FOURSQUARE AT STERLING RANCH EAST FILING NO. 1 GRADING AND EROSION CONTROL PLAN			
DESIGNED BY	DLG	SCALE	DATE 11-30-22
DRAWN BY	DLG	(H) 1" =	SHEET 2 OF 27
CHECKED BY	(V) 1" =	JOB NO.	1183.23

FOURSQUARE AT STERLING RANCH EAST
FILING NO. 1
GRADING AND EROSION CONTROL PLAN

CDOT MANHOLES
STD. PLAN NO: M-604-20

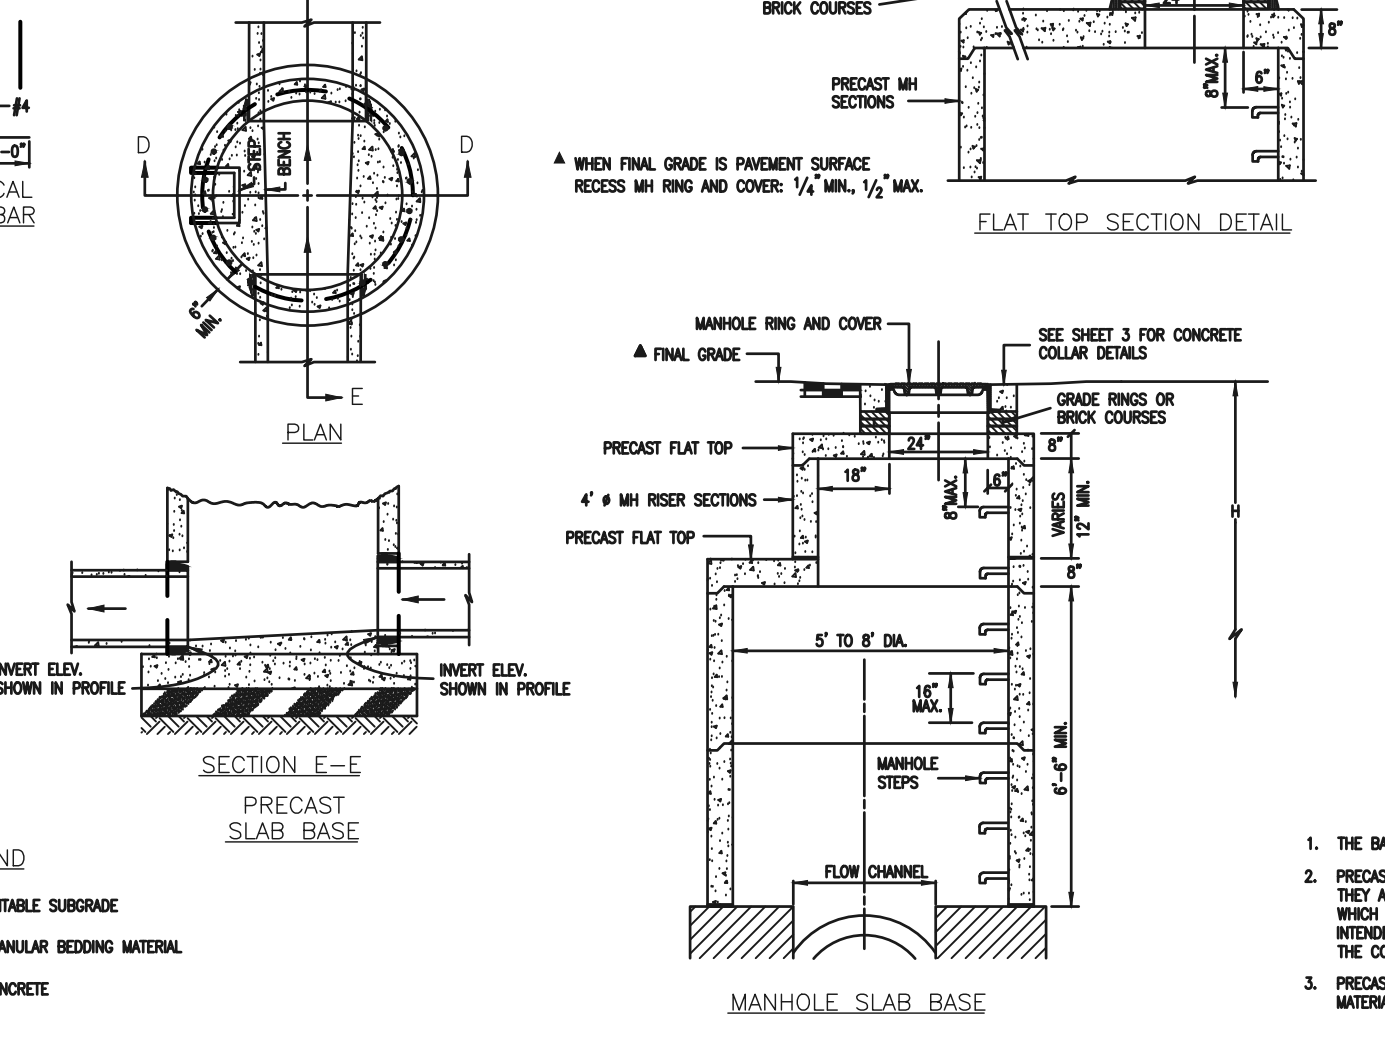
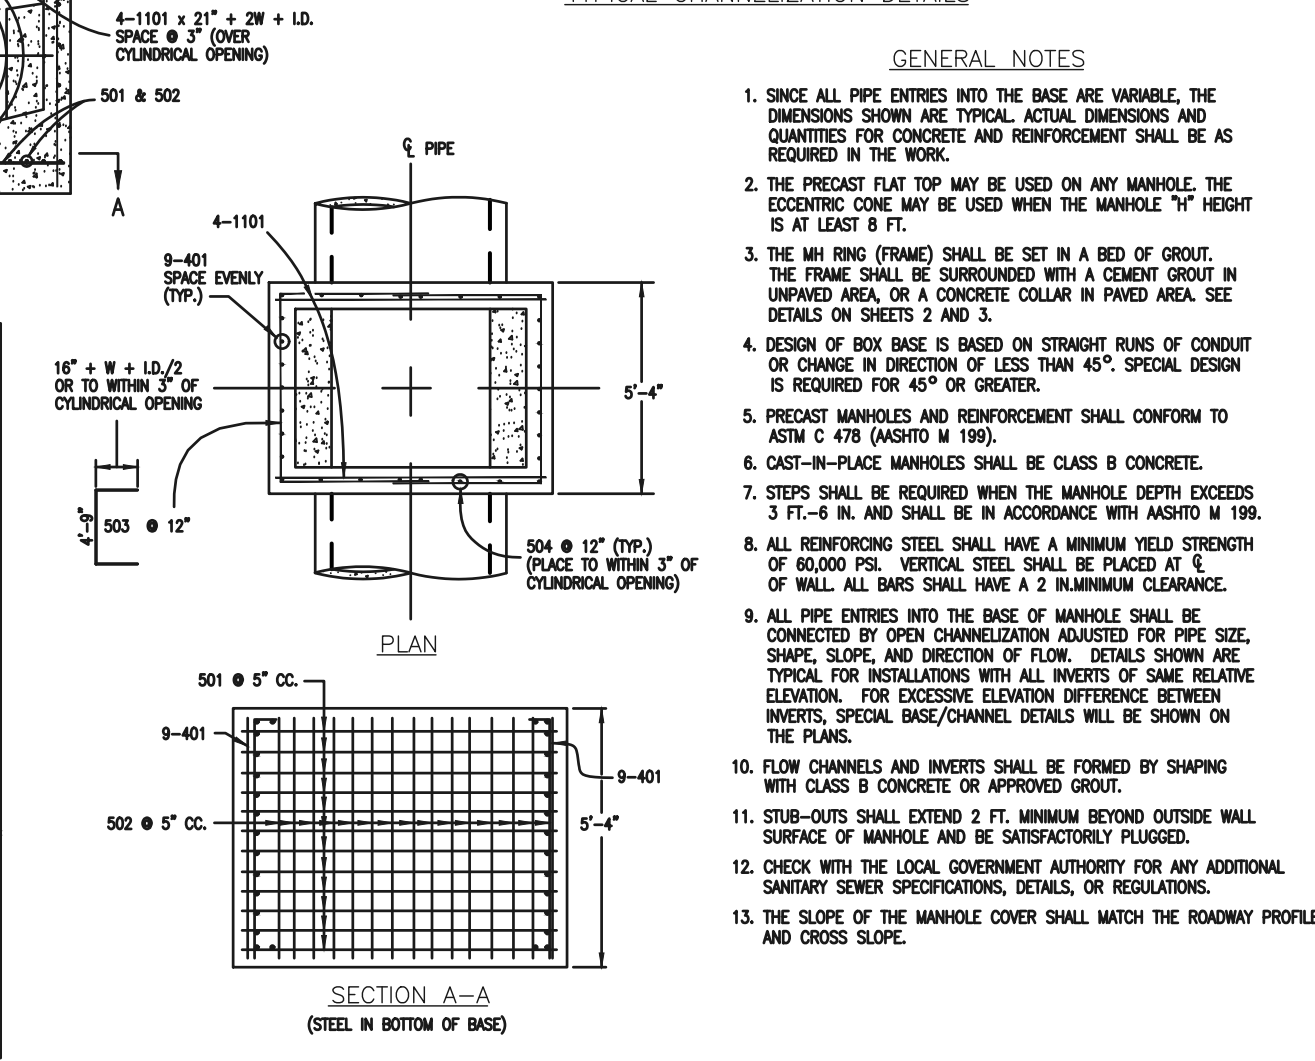
Add note that lettering/wording per EPC detail SD-3-5 is required or add that detail
